19 FEB 2026

AIRAC AMDT 01/26

VILNIUS (EYVI)
RNAV RMY 01
ATMEZ 1A, DUKAT 1A, ELEKA 1A,
LAFAT 1A, SOGBI 1A, UPASI 1A

EYVI AD 2.24-10-1

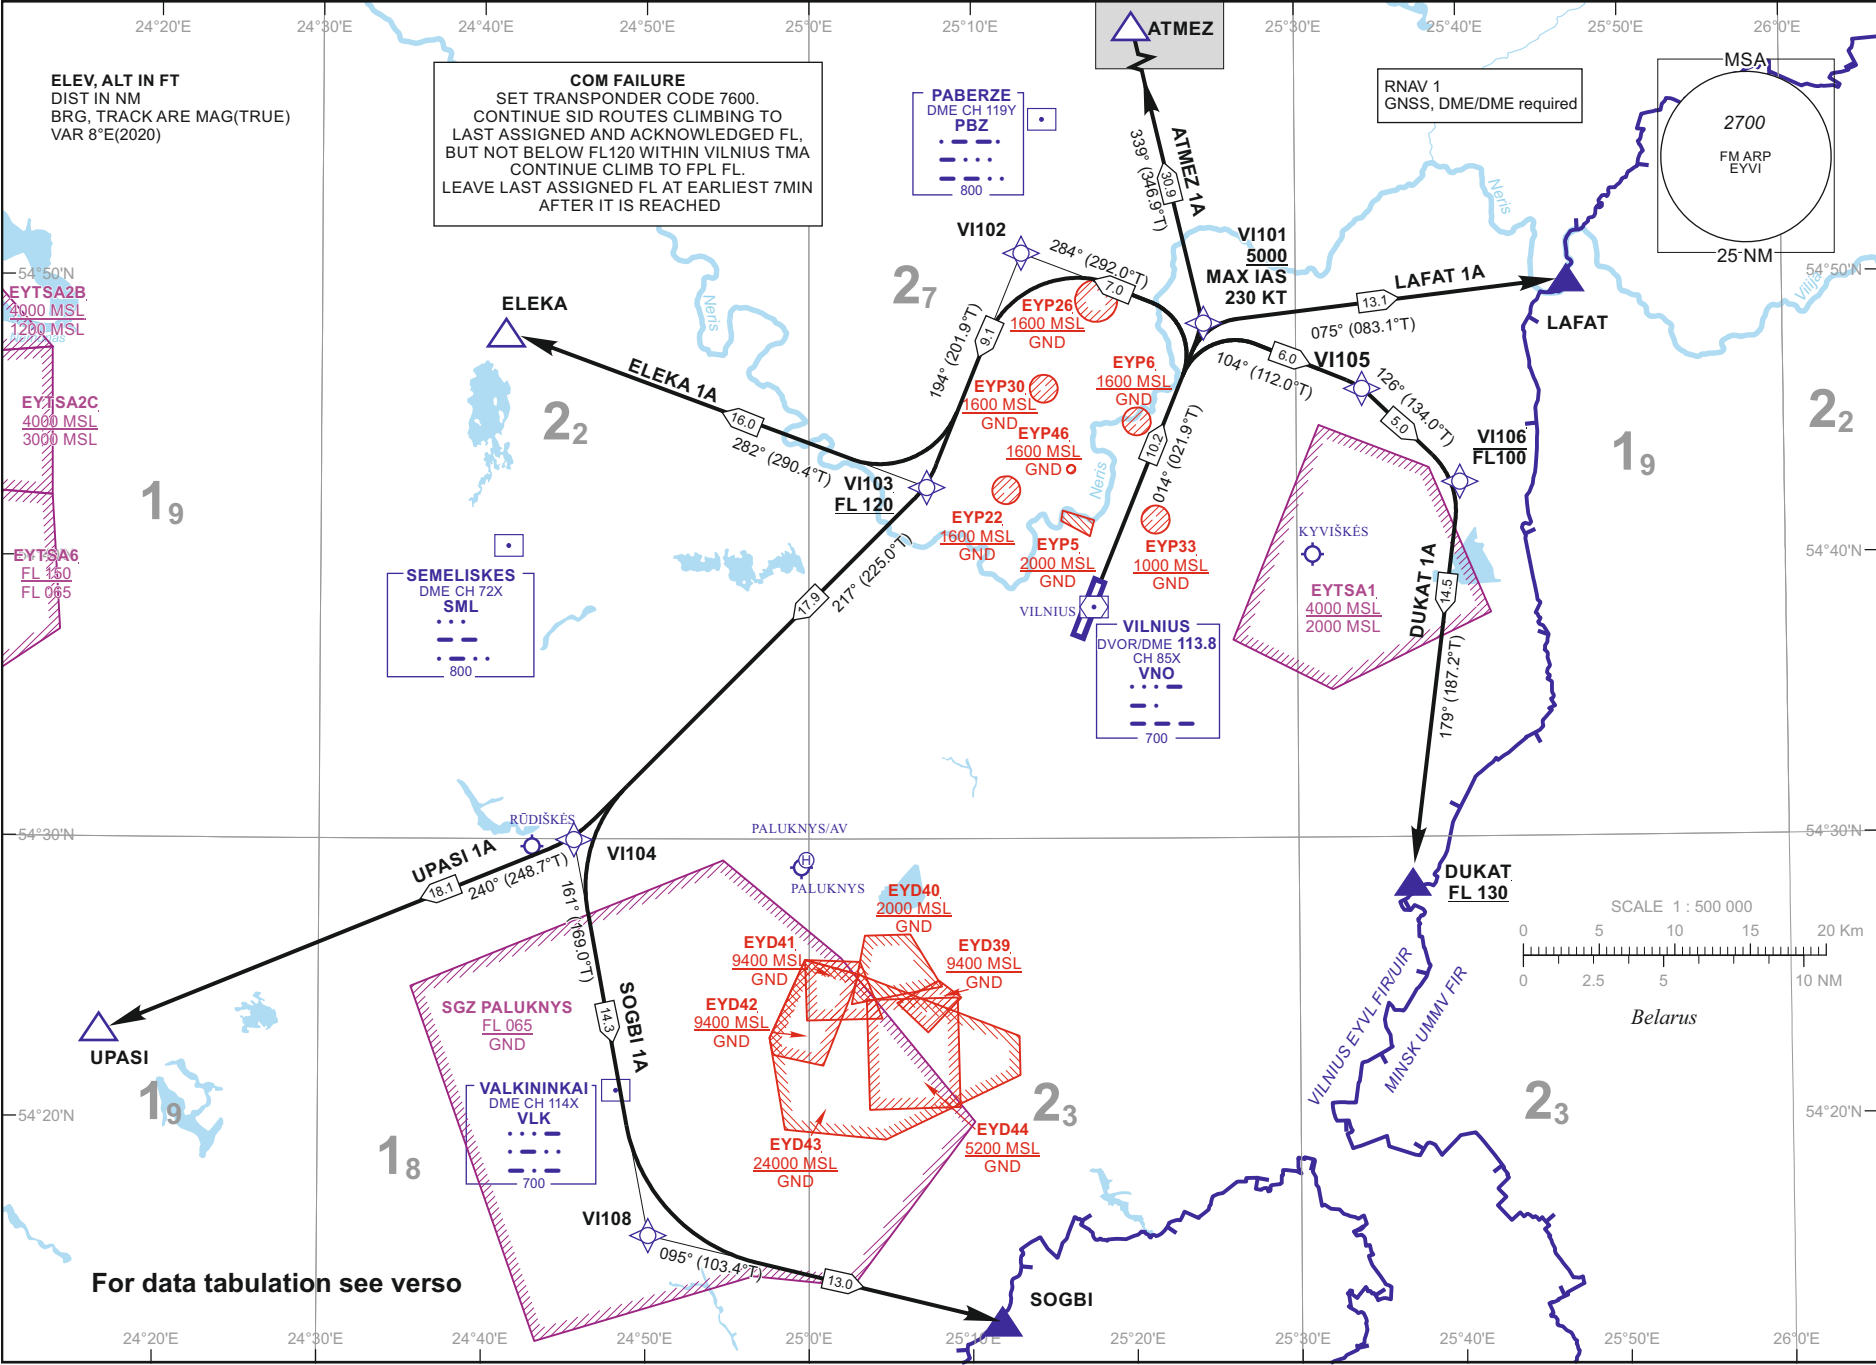
Changes: SID TAGOL 1A and EYP45 withdrawn; SID ATMEZ 1A and EYP46 added; note.
